Issued by Canon Europa N.V.

**iR3530  
iR2230**

iR4570-008  
(F1-T01-0M4-10018-01)

Introducing a new model (iR2230/3530)

F-1

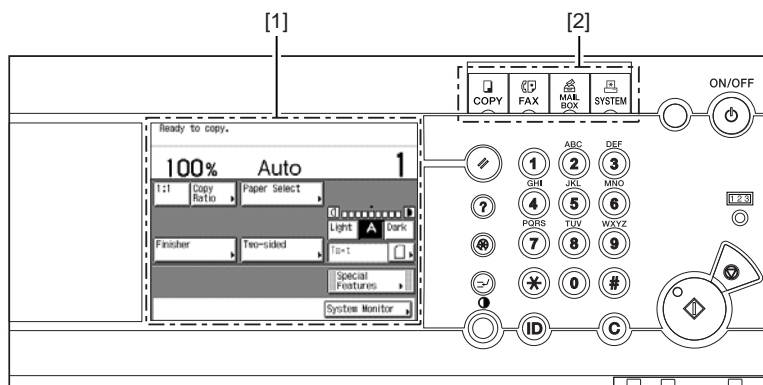
### Change of the control panel unit

- [1] The LCD has become smaller and black-and-white.
- [2] The function keys have become hard keys.

F-2

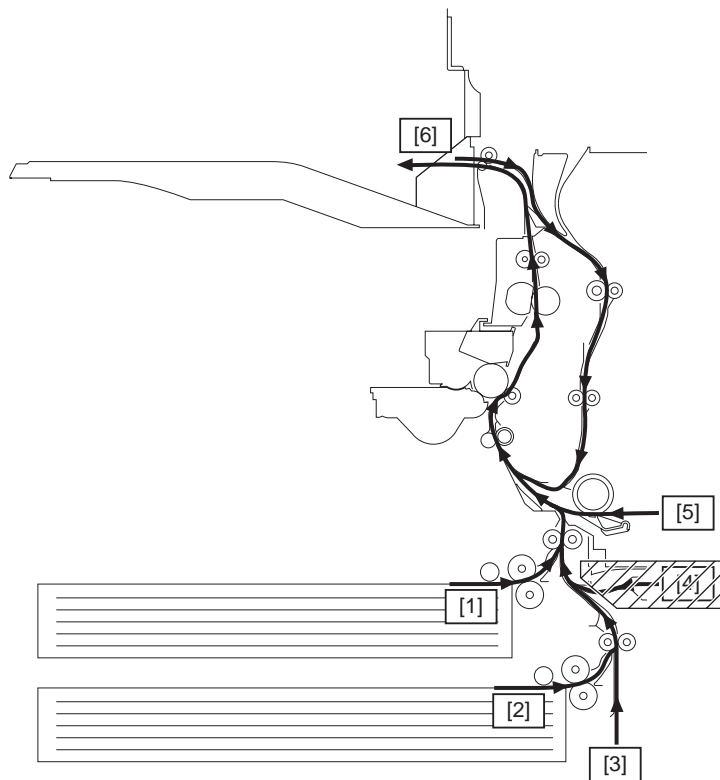
The Paper Deck-Q1 has been deleted from options. With this change, the paper pickup areas from the paper deck are eliminated from the paper path illustrations.

The eliminated areas are shown below.

- [1] Pickup from the Cassette 1
- [2] Pickup from the Cassette 2
- [3] Pickup from the Cassette Feeding Unit (option)
- [4] Pickup from the Paper Deck (**delete**)
- [5] Pickup from the Manual Tray
- [6] Deliver to the Copy Tray 1

F-3

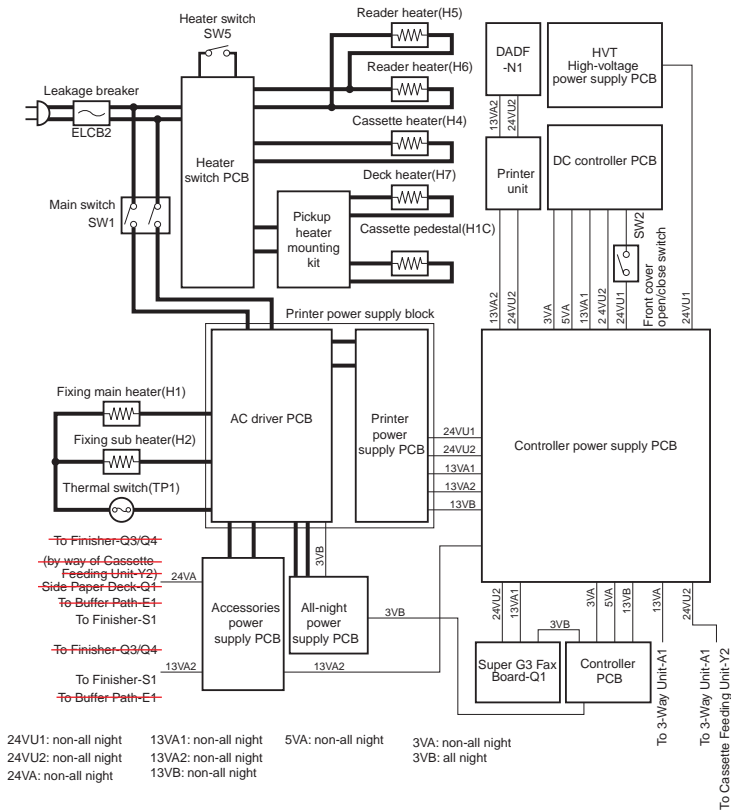
Some pickup/delivery options have been deleted. With this change, the names of options to which power is supplied are eliminated from the power supply illustration on the Service Manual.

F-4

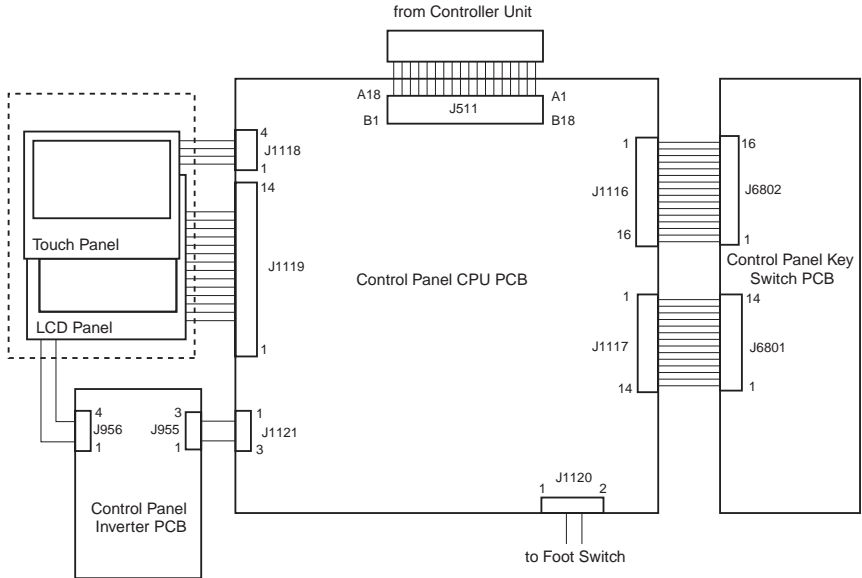
As mentioned above, the LCD has become black-and-white, and the hard keys have been added. Therefore, the board connection in the control panel unit is changed. The changed blocks are shown below.

F-5

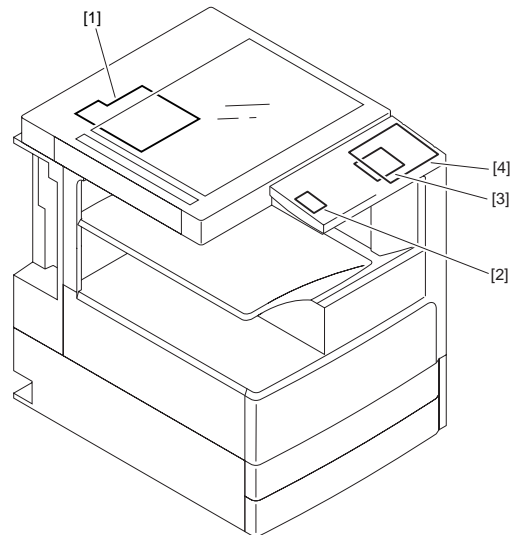
The electrical parts related to the control panel unit are placed as shown below. The parts [2] to [4] are related to the control panel unit.
